# Bournemouth, Dorset and Poole Waste Plan Site Allocation – December 2017

Reference: Inset 6

Site Name: Old Radio Station, Dorchester

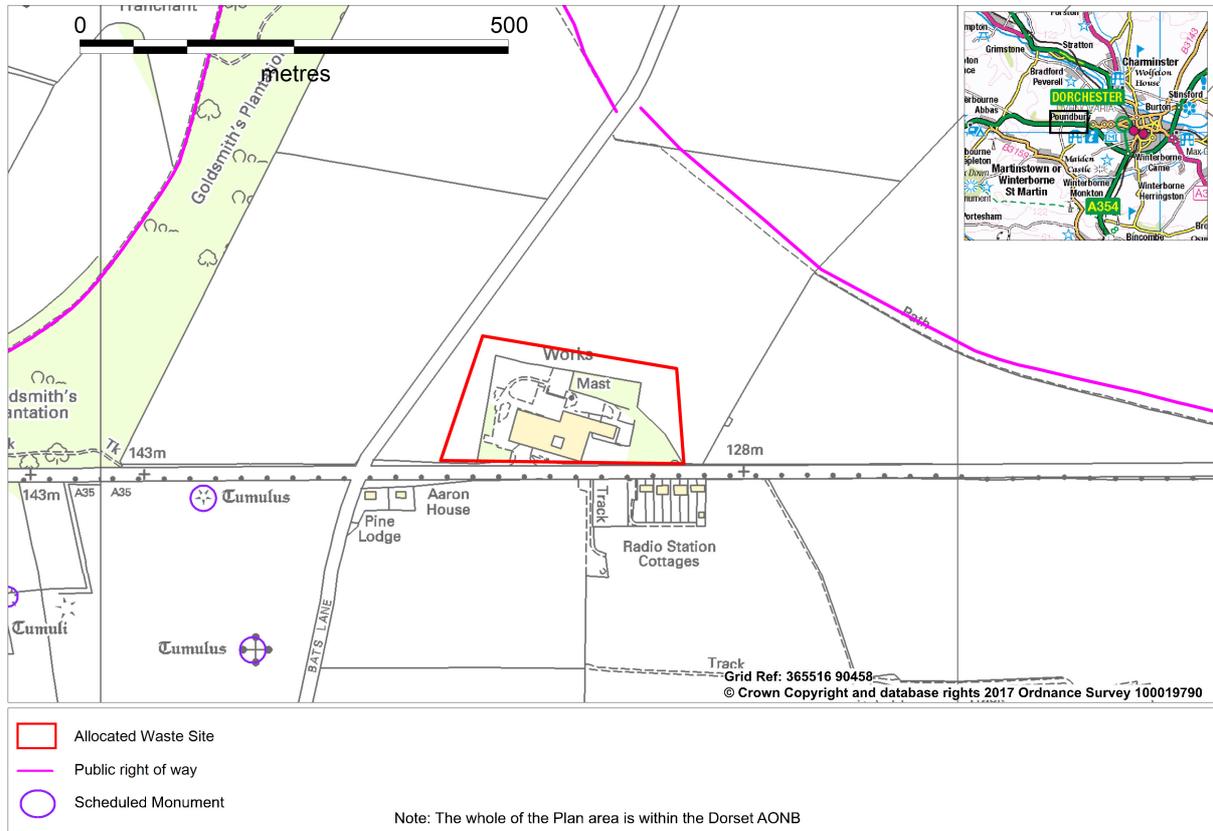
<p><b>Traffic/Access</b></p>	<p><u>Local Highways Authority (DCC)</u>  <u>Initial comments 17/09/14 (relating to possible uses as transfer, depot and household recycling centre):</u>  Strong highway objection from DCC for all uses except depot facilities - would lead to traffic generation on the A35/A37 out of the Town. Highway Agency will need to comment on A35.</p> <p><u>Revised comments 10/02/2016 (relating to transfer and depot facilities only):</u>  No objection from DCC Highways - Highways England are the Highway Authority for the A35</p> <p><u>Highways England Initial Comments (September 2014)</u></p> <p>This site is only a few hundred metres to the west of WD01 - our concerns are broadly similar. Whilst the site is currently used as a bus depot so has an access the number of existing turning movements are likely to be small. An HRC in particular would be in excess of 116,500pa one way car movements, presumably mainly coming from Dorchester and therefore having to turn across oncoming traffic to enter the site. All traffic using the site would have to use the Strategic Road Network and the proposal is likely to raise significant capacity and safety concerns. The HA has significant concerns about the potential impact of this site and all other options should be explored first.</p> <p>If a Waste Transfer Facility or a Depot was proposed on the site, subject to the provision of a transport evidence base in line with requirements, given the current use of the site the Agency would not envisage any major issues</p>	<p>Transfer/depot</p>

<p><b>Land Instability</b></p>	<p>No issues identified</p>		
<p><b>Landscape &amp; Visual Impact</b></p>	<p>Site lies within Dorset AONB</p> <p><u>Senior Landscape Officer, DCC (13/08/14)</u></p> <p><b>1. Context</b> Within the Dorset AONB and within the chalk valley and downland landscape character type.</p> <p><b>2. Key Characteristics</b></p> <ul style="list-style-type: none"> <li>○ Dominated by large scale existing buildings next to the busy A35.</li> <li>○ Visually prominent structures/buildings seen on the skyline from surrounding viewpoints.</li> <li>○ Prominent white building colour increases its visual impact.</li> <li>○ Significant surrounding trees and vegetation around the site.</li> </ul>

<p><b>3. Landscape Value</b>  The site has little landscape value due to the large structures and buildings in an open chalk upland setting which creates a significant visual impact. In particular the site is on a prominent skyline and is visible from long range and close up views, in particular from the south in the direction of Maiden Castle. The existing trees and other vegetation around the site do help to reduce some of the visual impact on the site.</p> <p><b>4. Landscape Susceptibility to Waste Management Facility Development and Opportunities for Mitigation and/or Enhancement</b>  The area has high susceptibility to the development in question due to the large buildings and their prominent location which already creates an adverse landscape and visual impact in this part of the open countryside in the Dorset AONB. There would however be opportunities for mitigation and/or enhancement if this site had to be considered and was brought forward. This would include ideally re-using existing buildings and changing their appearance by using a recessive colour, reinforcing and managing the structural planting around the site and the roadside hedgerows leading up to the site.</p> <p><b>5. Conclusion</b>  Only if a suitable mitigation package could be agreed based on the opportunities mentioned above it may be possible to reduce the adverse landscape and visual impacts identified for this site and progress with the development option on this site.</p> <p><b>See also 'design guidelines' for this site below.</b></p>

<b>Development Considerations</b>
<p>The Development Considerations for each site comprise specific requirements, issues and opportunities that should be addressed through a planning application. They are set out in the Waste Plan and reproduced within this site assessment for completeness. It should be noted that the Development Considerations do not comprise an exhaustive list of matters to be considered.</p> <ol style="list-style-type: none"><li>1. Landscape-led masterplan approach to the design of the site to mitigate any adverse landscape and visual impacts, taking into account the setting of Maiden Castle Scheduled Monument, and to provide enhancement opportunities.</li><li>2. Transport assessment to accompany and inform application</li><li>3. Phase 1 habitat survey and bat survey to accompany and inform application</li></ol>
